| <b>Project Title:</b>   | 2019 Title 24, Part 6, Building Energy Efficiency Standards Rulemaking              |
| <b>Document Title:</b>  | Statewide Utility Codes and Standards Team Comments HVAC System Filter Requirements |

# Comments on HVAC System Filter Requirements in 2019 Title 24, Part 6 45-Day Language

**Figure 2: Pressure drop versus airflow for all filters tested**

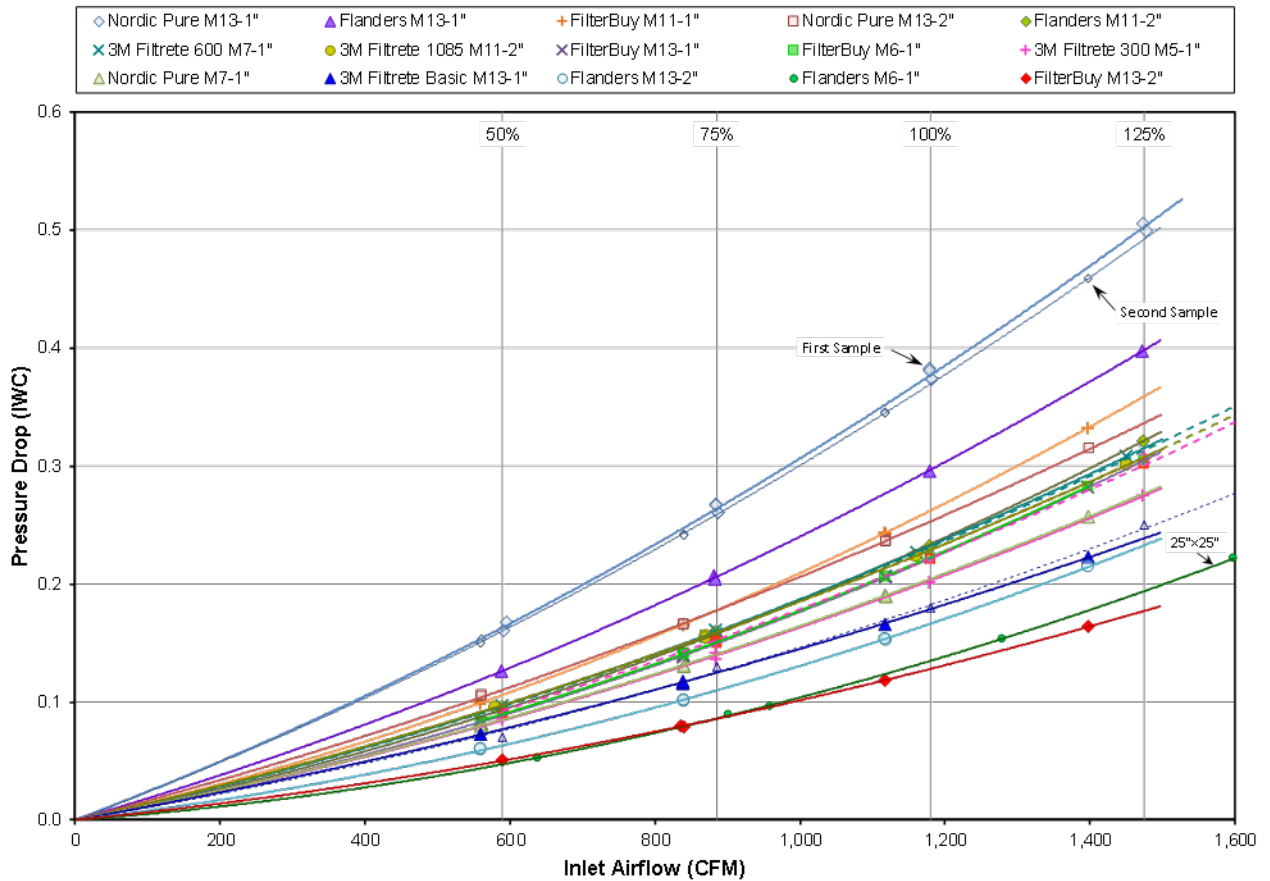
Figure 4 graphs the performance of all filters tested. The legend indicates the MERV rating and the filter depth (e.g., M13-2" is a two-inch deep MERV 13 filter).

The dotted lines are plots of manufacturer performance data and show reasonably good alignment with ATS lab test results. Tests of two Nordic Pure MERV 13 filters were completed with similar results. As with Table 2, the plot shows there is no direct correlation of MERV rating to pressure drop performance. For example, the MERV 7 Filtrete 700 curve is above the MERV 13 Filtrete Basic.

Regarding the perception that larger filter grilles will be needed for MERV 13 filters, Figure 2 clearly shows that filter pressure drop does not correlate to MERV rating, and that if filters are selected carefully using labelled pressure drop data, implementers should not encounter this problem.

**Figure 3: Pressure drop versus airflow for only the MERV 13 rated filters**

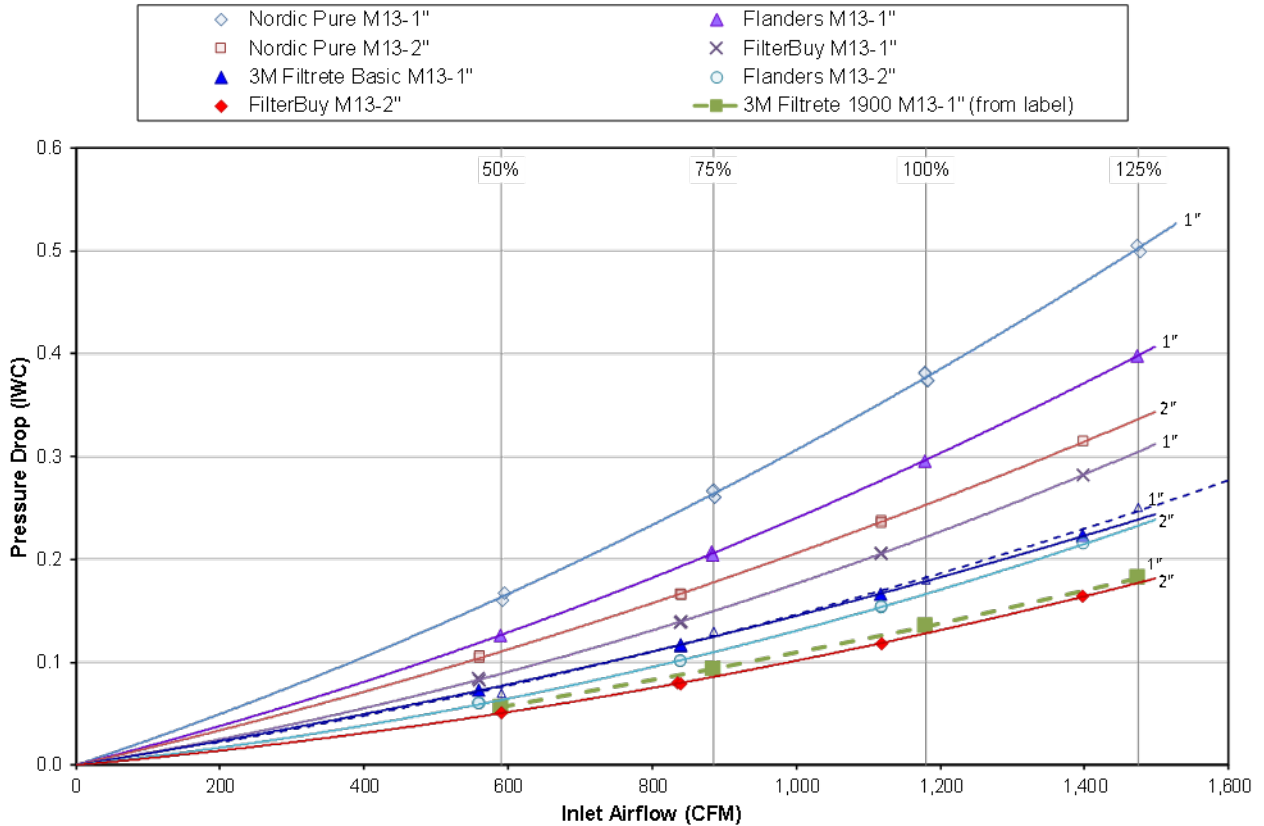
Figure 5 shows only the curves for MERV 13 filters. The MERV 13 Filtrete Basic filter tested is not one that is commonly available in retail stores, but can be ordered and has a lower price than the commonly available Filtrete 1900. For comparison, a curve fit of the label data from a Filtrete 1900 was included in the Figure 5 plot, which appears as the green dotted line. The curves in Figure 5 are also labeled to indicate the filter depth.

In response to stakeholder concerns regarding the difficulty complying with lower efficacy requirements, referring to Table 1, if filter pressure drop is kept at or below 0.15 inch w.c., then a total external static pressure of 0.7 inch w.c. should be easily achieved. Referring to Figure 3, five of the eight MERV 13 filters tested are at or below 0.15 inch w.c. at a velocity of about 225 fpm. From prior ATS testing of furnaces and heat pumps, it was learned that they can comply with a 0.45 W/cfm standard at or below external static pressures of 0.7 inches w.c.<sup>5</sup> Thus, if designers and contractors comply with the CALGreen mandatory requirement for system sizing using Manual D or other methods, then this concern can be dismissed.

especially for ceiling-mounted air handlers used in multifamily installations. Filter slots for many of these ceiling units are not designed for filters deeper than one inch and many, to conserve space, incorporate return air grilles in the air handler box rather than using ducted returns. Again, referring to Figure 3, all but three of the MERV 13 filters would meet the requirement for a pressure drop not to exceed 0.15 inch w.c. at a velocity of 225 fpm (or 900 cfm for the 24-inch by 24-inch filter size), so if they can meet the velocity limits then they could also meet the 0.15 inch w.c. pressure drop requirement in 150.0(m)12Biib.

Of the five filters shown in Figure 5 that fall at or below 0.15 inch w.c. static pressure at 225 fpm, three are one inch deep. This result does not support the requirement for two-inch filters, or the more rigorous requirements proposed for one-inch deep filters.
